HISTORIC AND DESIGN REVIEW COMMISSION

June 05, 2019

HDRC CASE NO: 2019-243
ADDRESS: 2218 W MAGNOLIA AVE
LEGAL DESCRIPTION: NCB 6829 BLK 0 LOT 19
ZONING: R-6, H
CITY COUNCIL DIST.: 7
DISTRICT: Monticello Park Historic District
APPLICANT: Rufino Hernandez
OWNER: Rufino Hernandez
TYPE OF WORK: Exterior modifications
APPLICATION RECEIVED: April 29, 2019
60-DAY REVIEW: June 28, 2019
CASE MANAGER: Huy Pham

West Elevation

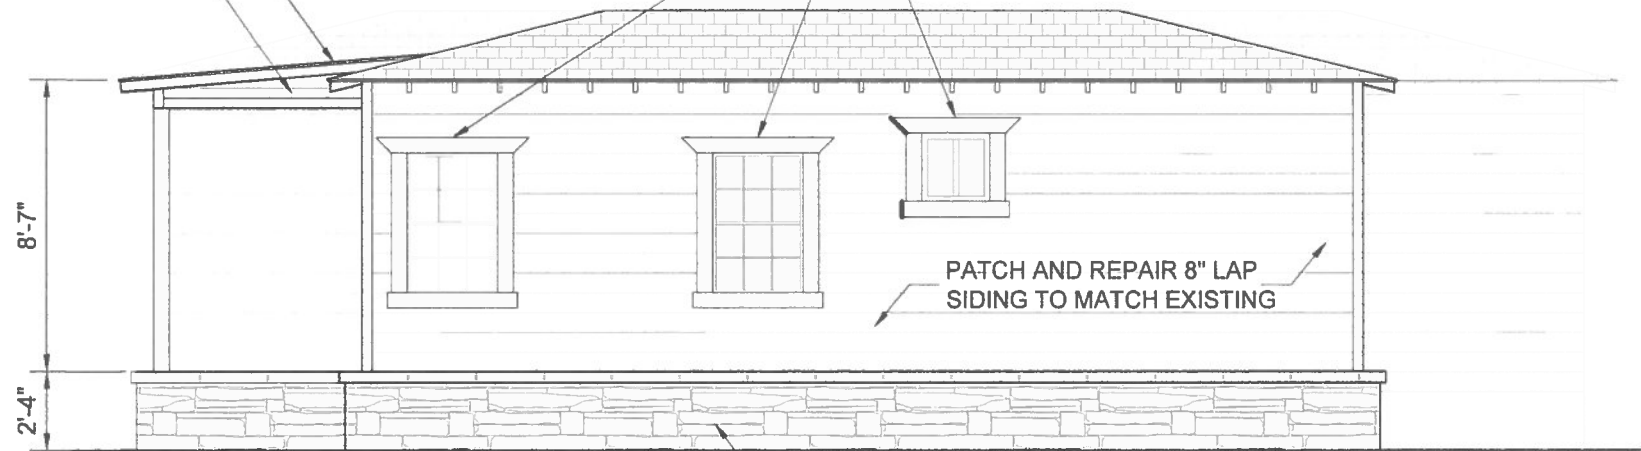
- e. SKIRTING MODIFICATIONS – The applicant has proposed to install limestone skirting throughout the structure. Per the Guidelines for Exterior Maintenance and Alterations 8.B.i., replacement skirting should consist of durable, proven materials, and should either match the existing siding or be applied to have minimal visual impact. Staff finds that the limestone skirting is a major departure from the minimal traditional style and should be removed. The structure should feature the simple exposed concrete skirting. Smooth Hardie plank with no faux wood grade may be installed at grade to prevent water infiltration.

- f. WINDOW TRIM – The applicant has proposed to replace the simple square window trim with a flared Craftsman style trim on all window through the structure. Per the Guidelines for Exterior Maintenance and Alterations 6.B.iv., window details should only be replaced in-kind when deteriorated beyond repair. Staff finds that the Craftsman detail is a departure from the minimal traditional style structure and should be reversed.

Staff does not recommend approval of items 1 through 5 based on findings a through k. Staff recommends the applicant return the modified elements to their original condition and address the accessory structure's inconsistencies with the Guidelines.

2218 West Magnolia
Accessory Dwelling Unit

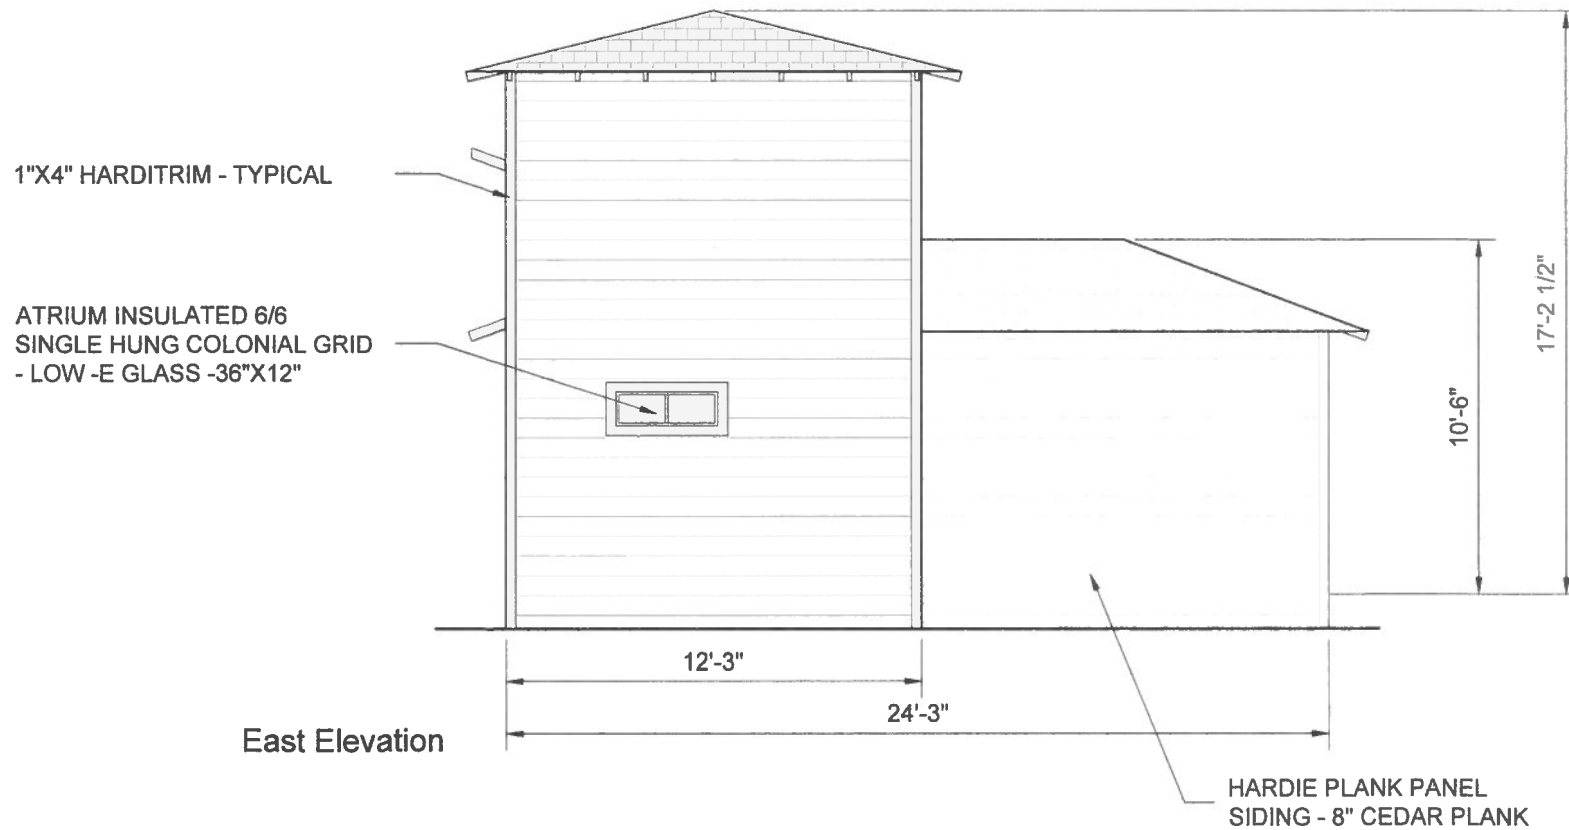
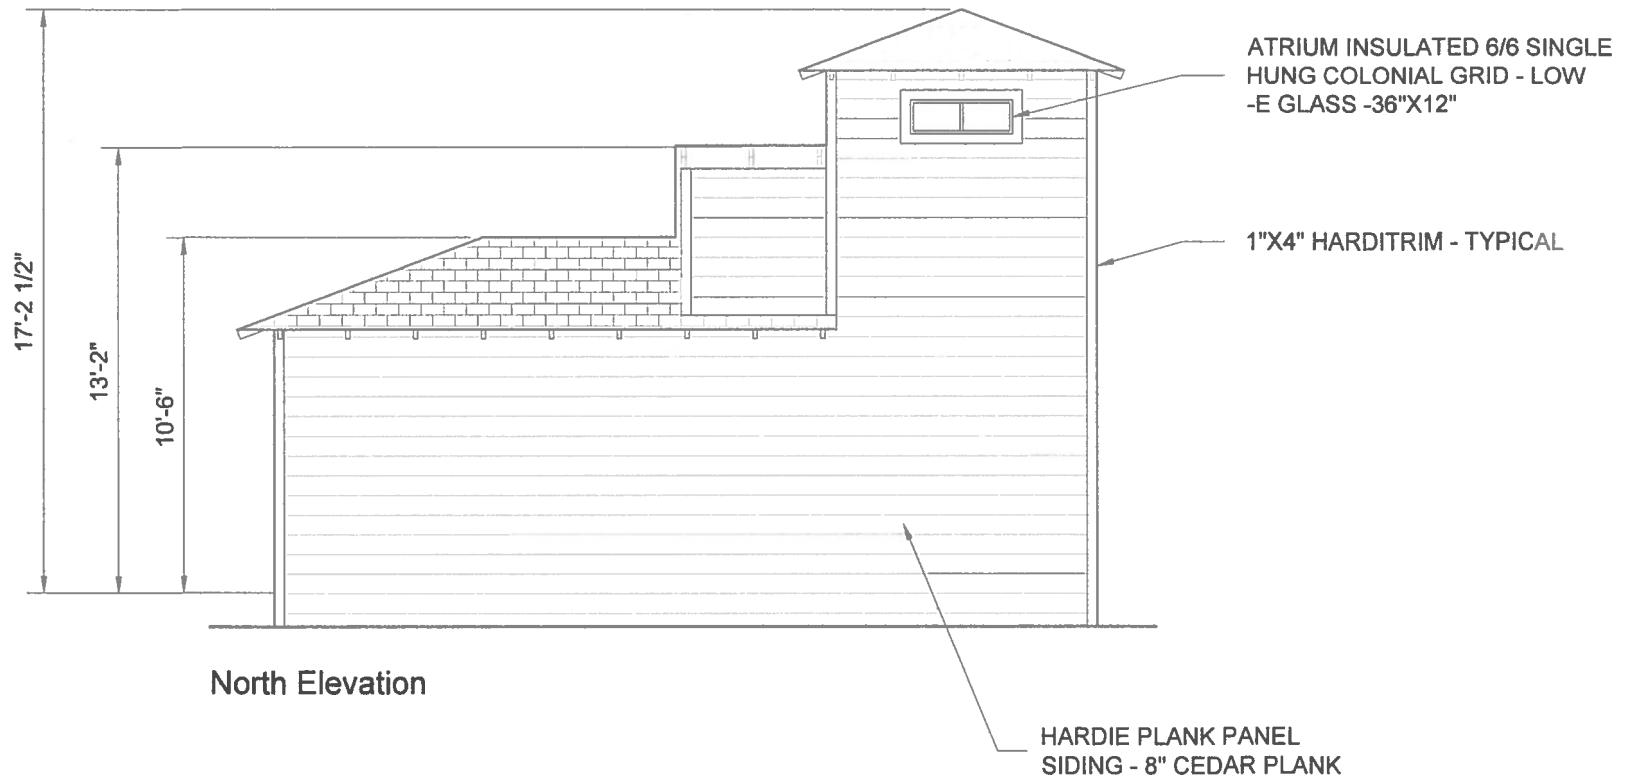
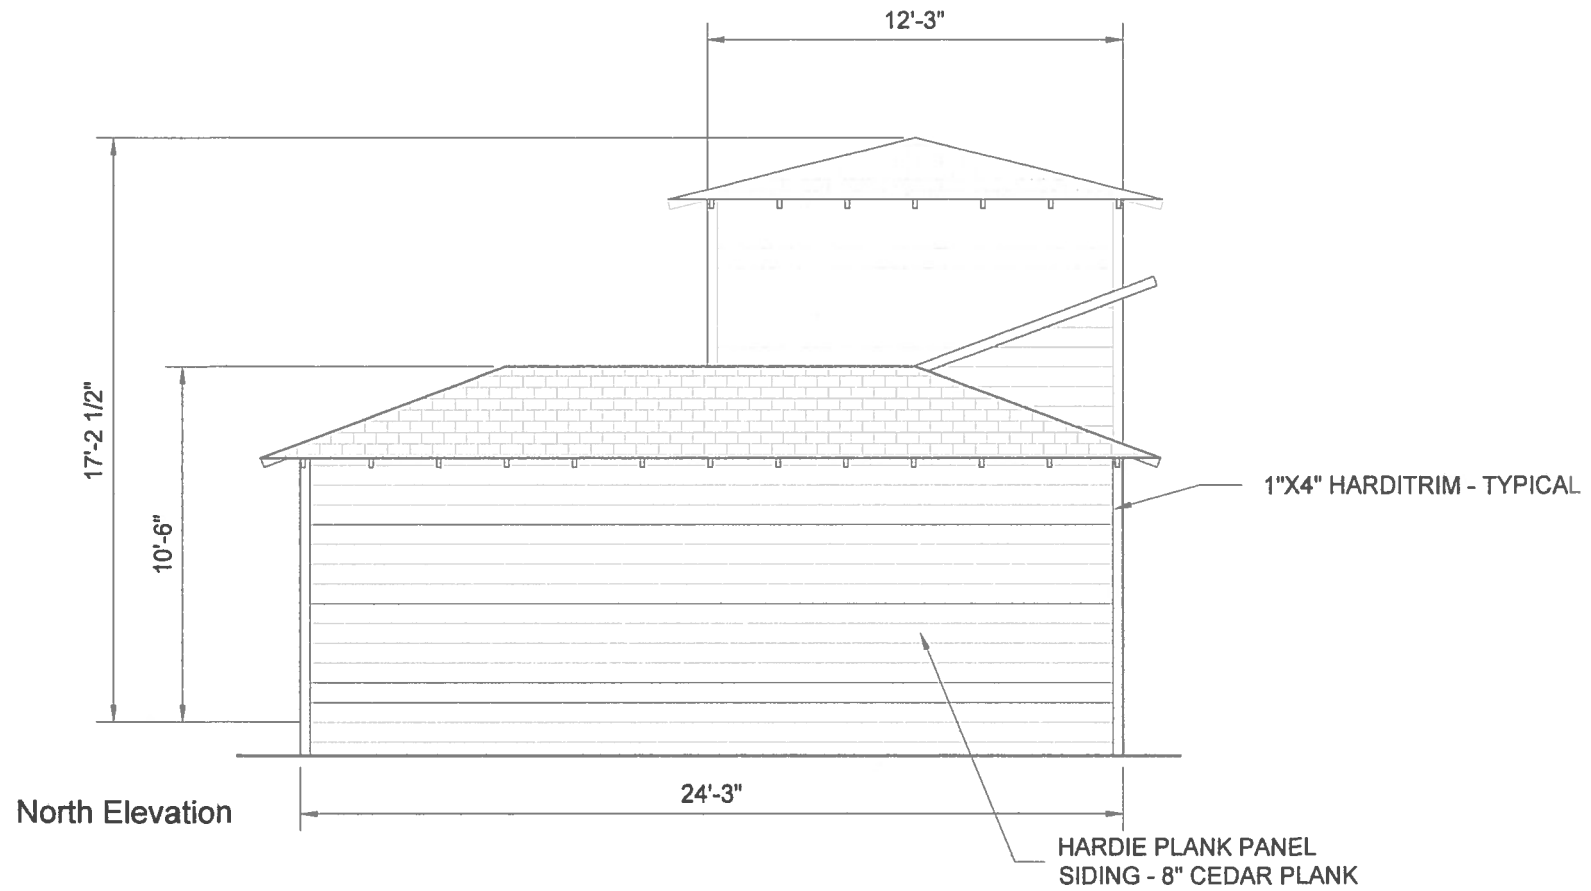
- g. REAR ACCESSORY STRUCTURE – The applicant has proposed to construct a 532 square foot rear accessory structure featuring a composition shingle roof, Hardie plank siding, five (5) vinyl windows, a nine-light steel door, a L-plan footprint, and a two-story square tower element.

- h. ACCESSORY MASSING, FORM, AND SIZE – The proposed accessory structure features an L-plan with one portion featuring a two-story square tower element. The structure also includes a variety of roof forms and heights: the first floor front-facing hipped roof turns to a shed roof before meeting the second-floor pyramid roof of the tower element. Per the Guidelines for New Construction 5.A.i., new garages and outbuildings should be visually subordinate to the principal historic structure in terms of their height, massing, and form. Staff finds that the two-story tower element of the accessory structure to be generally appropriate provided it is located at the rear of the lot and is minimally visible from the public right of way.

- i. ACCESSORY CHARACTER AND DESIGN – Per the Guidelines for New Construction 5.A.iii., new garages and outbuildings should relate to the period of construction of the principal building on the lot through the use of complementary materials and simplified architectural details. Excluding the use of composition shingles, divided light of windows, and lap siding, staff finds that the multiple roof forms, footprint, fenestration details regarding vinyl window size and configuration, door styles, and general massing is a major departure from the minimal tradition primary historic structure.

- j. ACCESSORY DOORS AND WINDOWS – Per the Guidelines for New Construction 5.A.iv., window and door openings should be similar to those found on historic garages or outbuildings in the district or on the principle historic structure in terms of their spacing and proportions. Staff finds that the use of square windows and sliding horizontal windows, the two different door styles, and the general spacing of fenestration elements to be a major departure from historic garages and outbuildings in the district and the minimal traditional primary historic structure. Additionally, staff finds that accessory structure windows should relate to the primary structure by featuring wood or aluminum-clad wood with exterior divided light details matching in trim and the standard stipulations: *Meeting rails that are no taller than 1.25” and stiles no wider than 2.25”*. White manufacturer’s
